Subject: MHI's Responses to NRC's Requests for Additional Information on Advanced Accumulator for US-APWR Topical Report MUAP-07001-P, Revision 2

MHI's Responses to NRC's Requests
for Additional Information

Advanced Accumulator for US-APWAR Topical Report MUAP-07001-P,
Revision 2

February 2010
(Non-Proprietary)

Fig. 2.2.1 One-dimensional model of a vortex in a vortex chamber

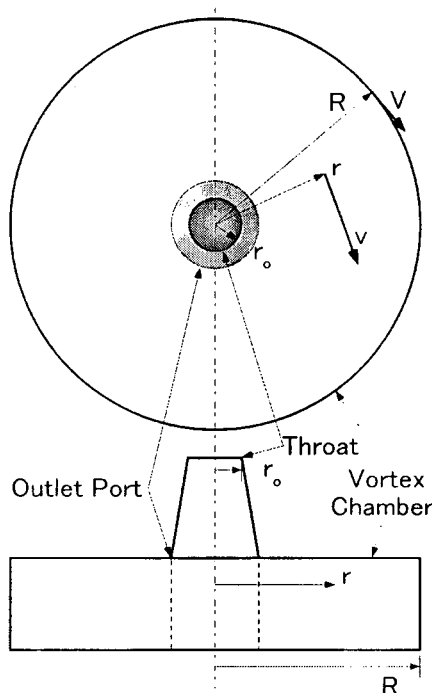
2.2 Explain the effect of diameter on the flow field and on the losses in the vortex chamber during small flow phase.

For small flow phase, a strong and steady vortex is formed in the vortex chamber. Figure 2.2.1 shows the one-dimensional model of a vortex for small flow injection. The tangential velocity, v , at a radius, r , is expressed as;

where R is the radius of the vortex chamber, and V the velocity at $r=R$. If the exponent $n=1$, Equation (2.2.1) expresses a forced vortex, while if $n=-1$, Equation (2.2.1) expresses a free vortex. Practically, n is between -1 and 1, and depends on the configuration and the size of the vortex chamber and the property of water. The diameter, $2R$, will, thus, affect the flow field through its ratio with respect to an arbitrary diameter, $2r$, in the vortex chamber.
